**SUBJECT:** Savannah River Site's Responses to the Regulatory Comments on the Biennial Effectiveness Monitoring Report (EMR) for Monitored Natural Attenuation (MNA) at the C-Area Burning/Rubble Pit (131-C) and Old C-Area Burning/Rubble Pit (NBN) Operable Unit (U), January 2015 through December 2016 (SRNS-RP-2017-00229, Revision 0, June 2017) CERCLIS Number: 31

**SRS Responses to South Carolina Department of Health and Environmental Control's  
Comments on the Biennial Effectiveness Monitoring Report (EMR) for Monitored Natural  
Attenuation (MNA) at the C-Area Burning/Rubble Pit (131-C) and Old C-Area  
Burning/Rubble Pit (NBN) Operable Unit (U) – January 2015 through December 2016,  
CERCLIS Number: 31 (SRNS-RP-2017-00229, Revision 0, June 2017) received June 8, 2017  
Page 1 of 4**

**SRS Responses to EPA comments on the Biennial Effectiveness Monitoring Report (EMR) for Monitored Natural Attenuation (MNA) at the C-Area Burning/Rubble Pit (131-C) and Old C-Area Burning/Rubble Pit (NBN) Operable Unit (U), January 2015 through December 2016, CERCLIS Numbers: 31, SRNS-RP-2017-00229, Revision 0, June 2017, Savannah River Site NPL Site, South Carolina**  
**Page 1 of 12**

Figure 5. CBRP OU Groundwater Model Particle Tracks (WSRC-TR-2001-00298)

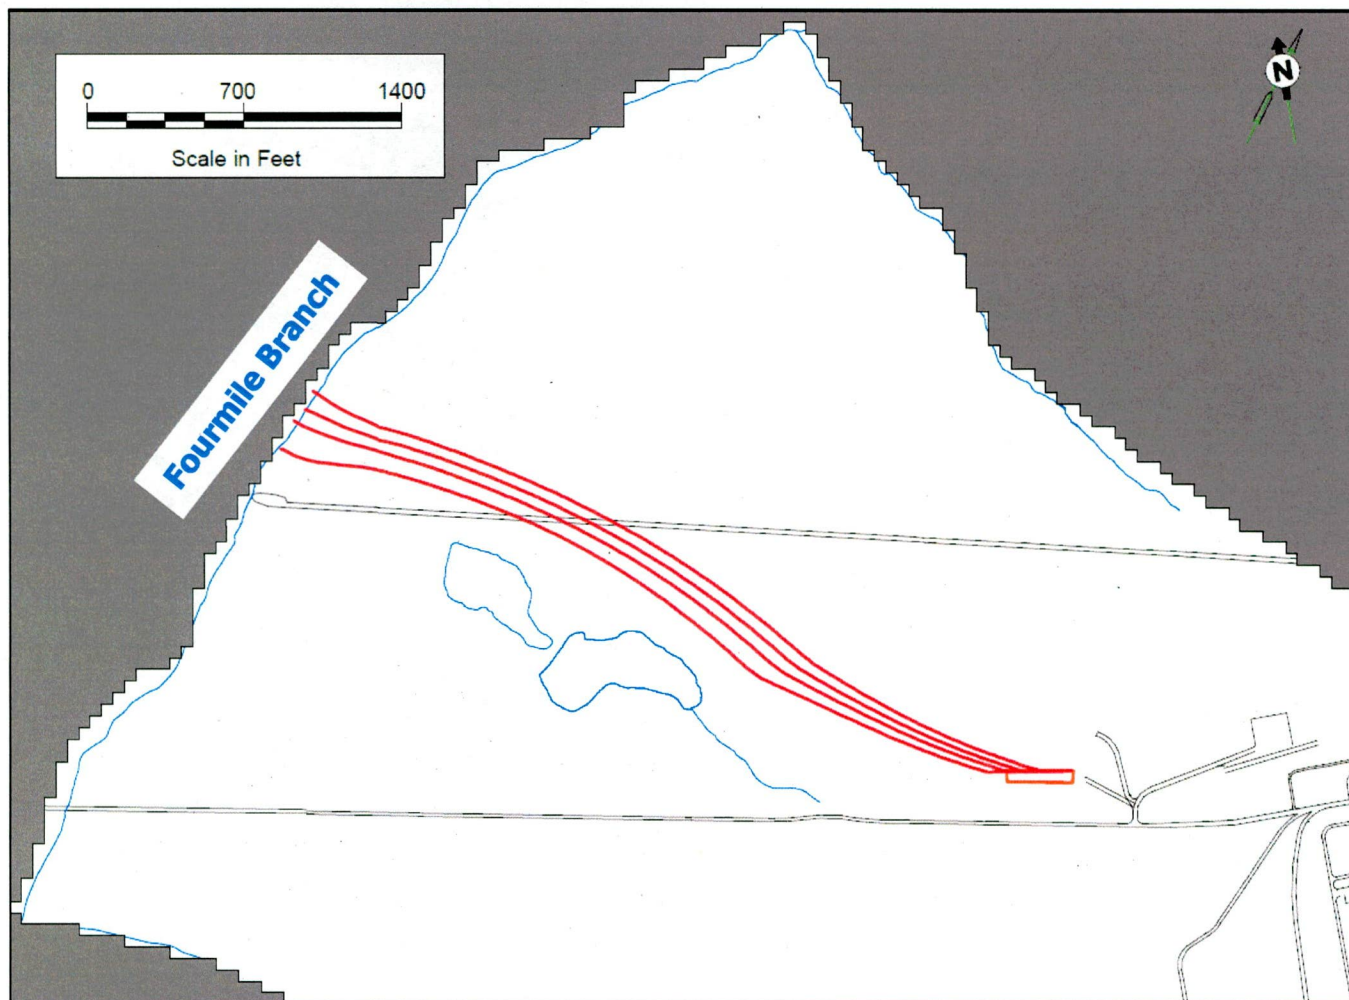
2. Figure 5, CBRP OU Groundwater Model Particle Tracks (WSRC-TR-2001-00298), page 25. This figure should be revised to indicate Fourmile Branch, as referenced on page 12. Please label accordingly.

**Response: Agree.**

**Figure 5, or equivalent, will be revised to label Fourmile Branch in the next EMR (See attached revised Figure 5).**

Figure 3. CBRP OU LUC Boundary

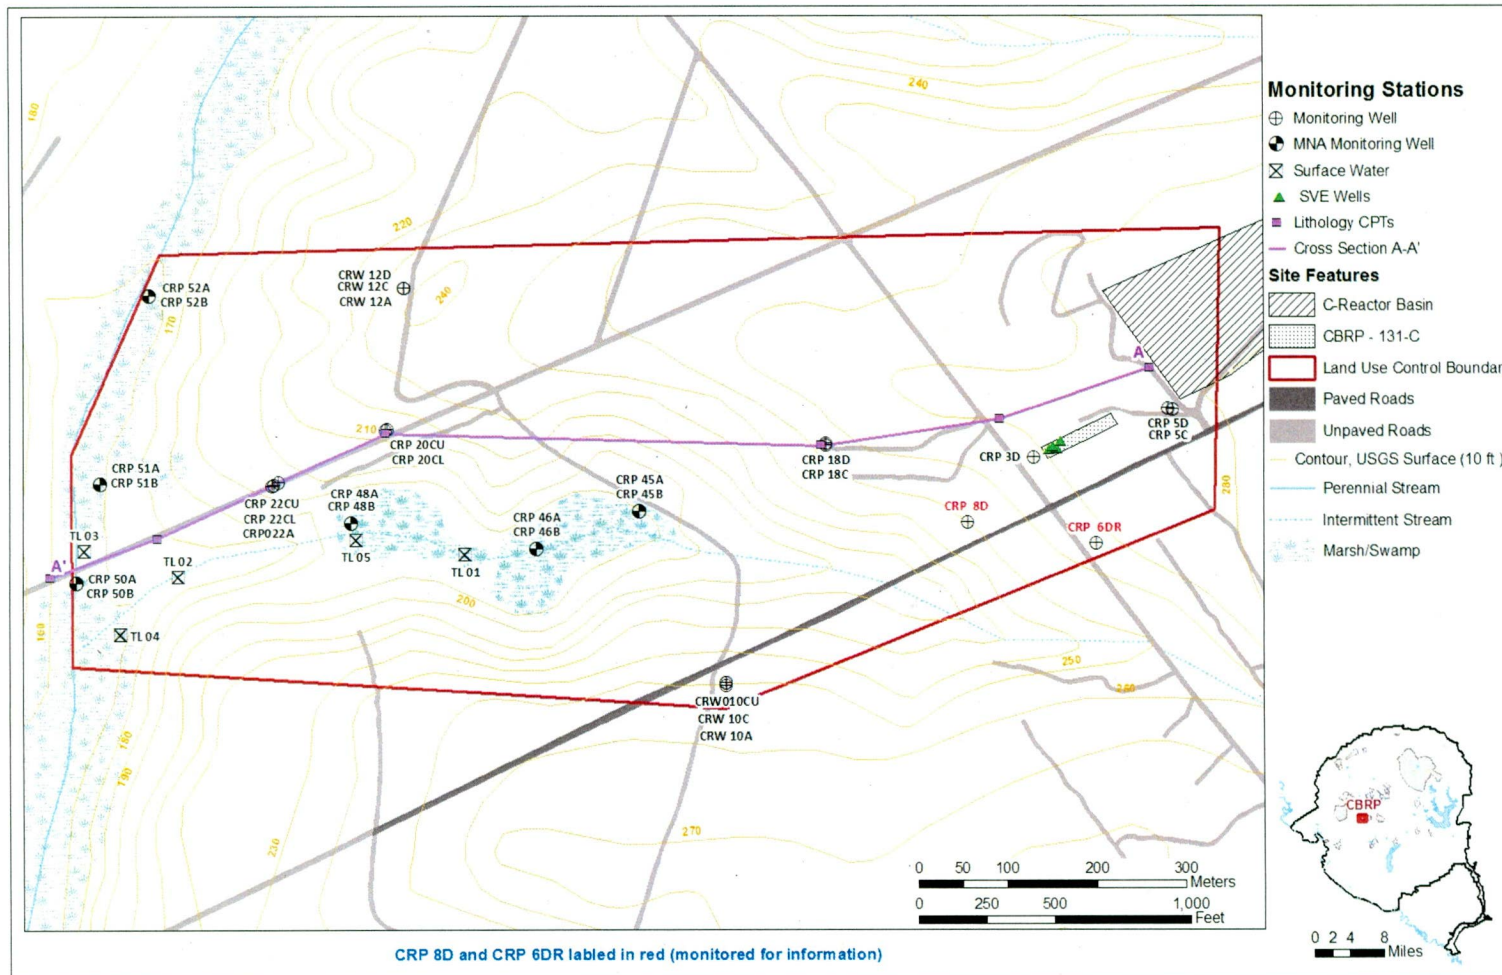
2. The Biennial Report presents cross-sections A-A' prepared for the TCE plume from monitoring data collected in 2000, 2012, 2014 and 2016. However, the line of cross-section A-A' is not illustrated on any of the plan maps presented in the Biennial Report. For clarity and completeness revise the Biennial Report to address this issue.

**Response: Agree.**

The cross-section line will be added to Figure 3 and the maps in Appendix D (See attached revised Figure 3 and Figures D-1 through D-5) in the next EMR.

Figure E-4. 2016 Water Elevations for the Middle/Lower Aquifer Zone of the Upper Three Runs Aquifer

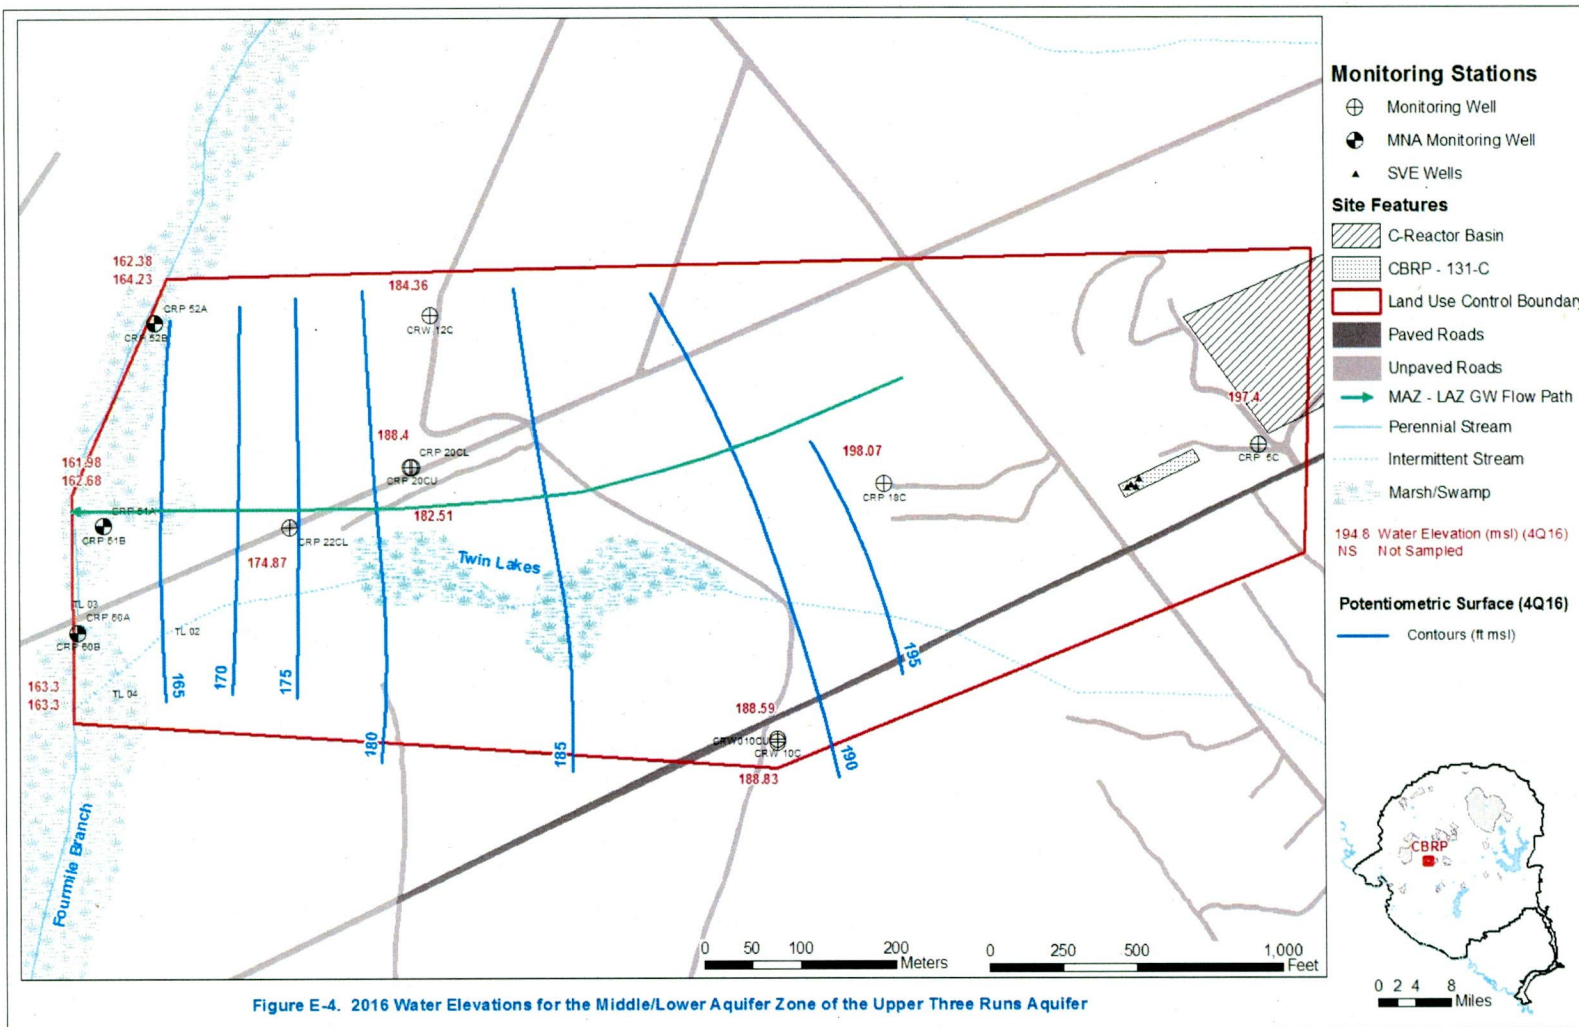
4. In Figure E-4, Water Elevations for the Middle/Lower Aquifer Zone of the Upper Three Runs Aquifer, Appendix E, Page E-6 of E-8, the water elevations are depicted for the well locations shown on the figure. However, the figure does not include the corresponding monitoring well designation or identification. For clarity and completeness, revise the Biennial Report to address this issue.

**Response: Agree.**

**The station names will be included on all potentiometric surface maps in the next EMR (See attached revised Figure E-4).**
